NL151532 B02v1

Re: 64-72 Warners Bay Road, Cardiff - Preliminary Flooding Advice

The following information has been compiled to provide additional information in response to a request from Lake Macquarie City Council (LMCC) on the 14/10/2016 regarding the assessment of the proposed Aged Care Facility at 64-72 Warners Bay Road, Cardiff.

Figure 1 - Flow Path Cross Section Locations

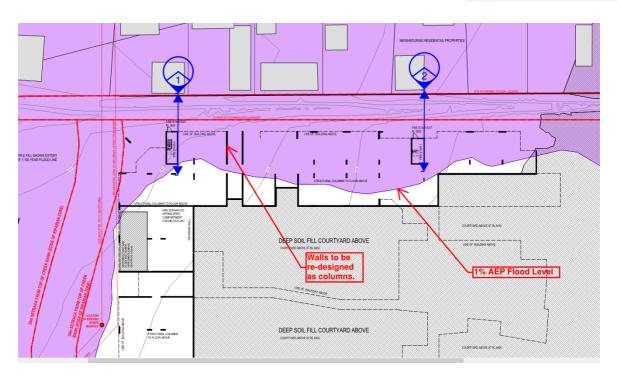
• The flood impact from the Warners Bay Road catchment is shown on the figures contained within Attachment 3 of the July 2016 Northrop report. These figures show that the western portion of the site is impacted by 100 year and PMF flows. Council is concerned that the constriction of these flows, by the development footprint, may increase impacts to the existing properties to the west of the development site. The last dot point of the Northrop report also highlights this. The South Creek Flood Study referenced in the Northrop report is the source of the flooding maps. These appear to have been based on the site is its current condition and without kerb and gutting in Warners Bay Road. The flooding extent needs to be analysed based on the development proposal footprint and the works in Warners Bay Road. The current level of information provided is inconclusive as to whether those existing properties to the west will suffer additional inundation.

To further assess the impact of the development footprint on the 1% AEP flows from the western catchment, cross-sections of the flow path have been taken at two locations where the building impediment is at its greatest. The section locations are shown below in Figure 1 with the cross sections provided in Attachment 1, NL151532_SK01_[1].

Noting that the walls highlight in Figure 1 will be redesigned as columns, the only prominent obstructions proposed within the western 1% AEP flow path are the Fire Stairs. These stairwell structures are 2.8m wide and 7.4m and 5.8m long respectively at Sections 1 and 2. As shown in Attachment 1, the depth of flow at both proposed stair locations does not exceed 100mm and is located at its outer extents. Given this the impact of the stairwells on flooding depths is expected to be minimal. However, to offset the loss of capacity it is proposed that compensatory volume be provided by lowering the channel adjacent to the stairs as depicted in flood storage cross sections. The provision of compensatory capacity in the channel will more than offset the impact of the isolated obstructions and avoid any impact to flood levels.
